REGULAR MEETING OF THE
CITY OF CONCORD
DESIGN REVIEW BOARD

Concord **REPORT TO DESIGN REVIEW BOARD**

SUBJECT: **GARAVENTA MINOR HILLSIDE DEVELOPMENT PLAN USE PERMIT AND PRELIMINARY DESIGN REVIEW (PL140258-HM, DR)**

1 SOUTH ELEVATION (FRONT)
SCALE: 1/4" = 1'-0"

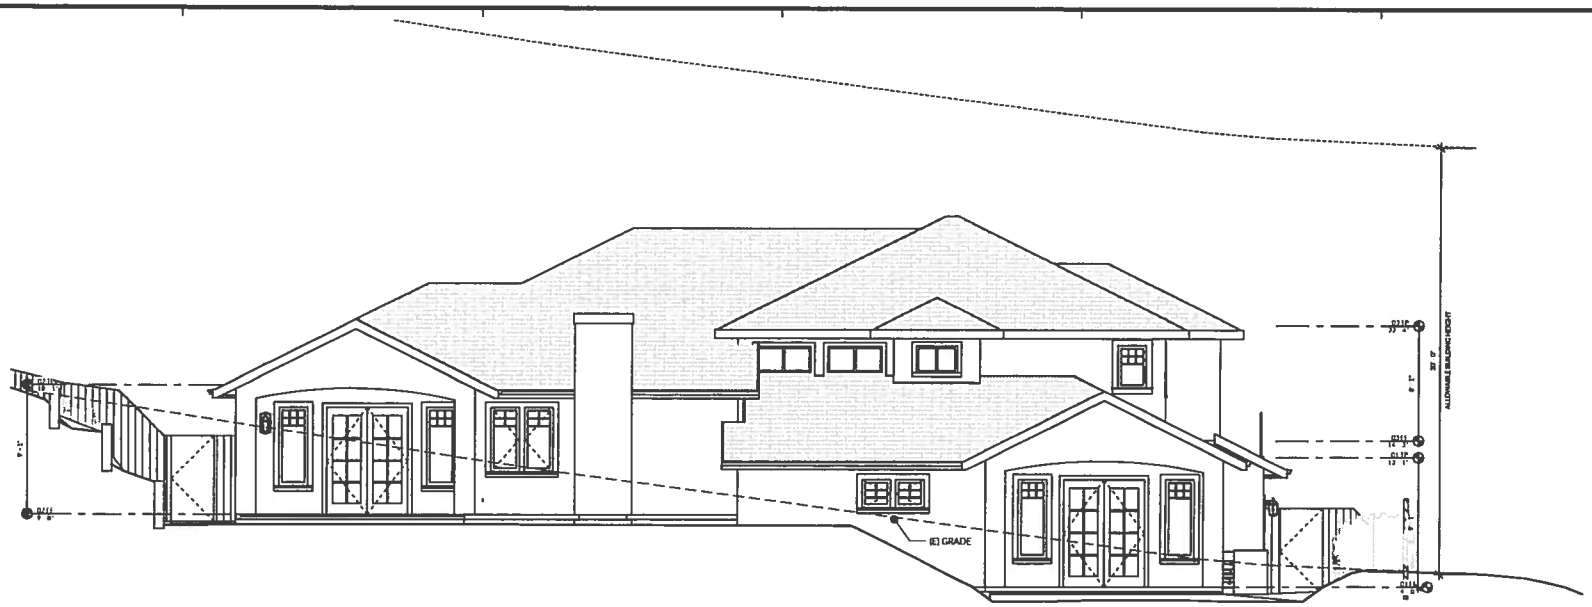
- Provide detailed building sections showing depth of overhangs, reveals, projections, window treatments, vents, and any other architectural features.
- Continue the horizontal siding and stone veneer to the right of the front door on the front elevation and around the west corner to promote design continuity.
- Wrap horizontal siding around entry columns.

- Provide detailed building sections showing depth of overhangs, reveals, projections, window treatments, vents, and any other architectural features.
- Continue the horizontal siding and stone veneer to the right of the front door on the front elevation to promote design continuity.
- Wrap horizontal siding around entry columns.

CONCEPTUAL LANDSCAPE PLAN
4090 BROWNING DRIVE, CONCORD, CA

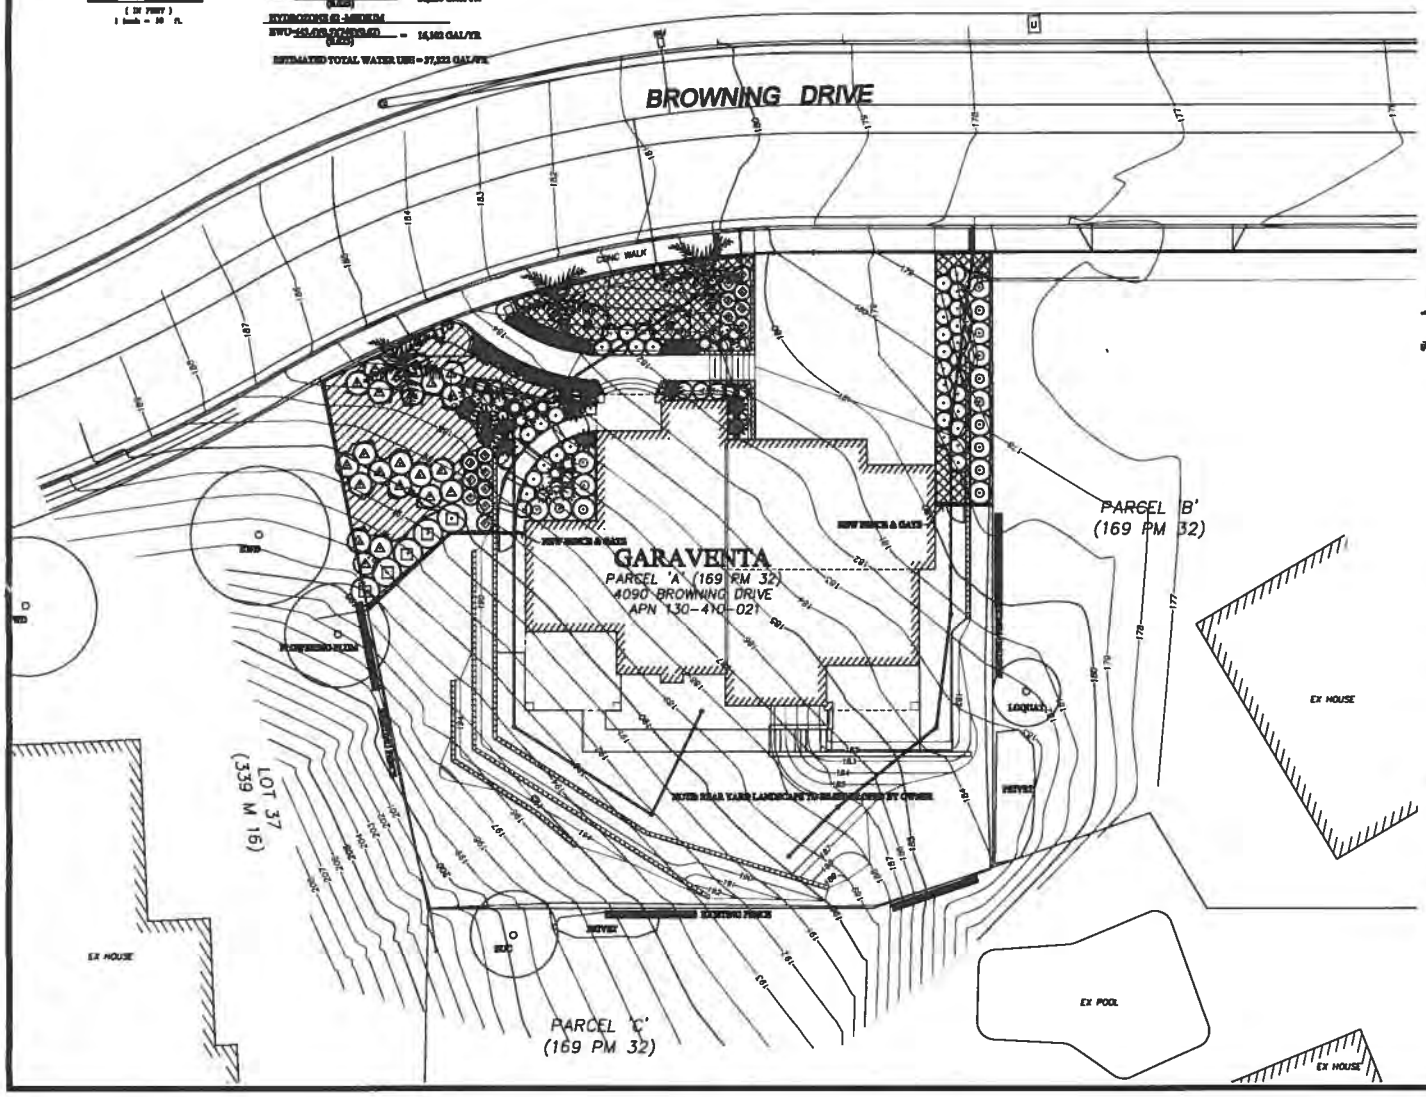
The landscape plan shows landscaping within the front yard area only. The palette includes three 24-inch box size Queen Palms, one five-gallon Red Crape Myrtle, one five-gallon Violet

Crape Myrtle, a wide variety of shrub types, and two species of groundcover. All of the existing trees are proposed to be removed. No protected trees would be removed as there are none located at the subject site. Staff's comments on the landscape plan are as follows:

- All trees to be a minimum 24-inch box.

- All trees to be a minimum 24-inch box.
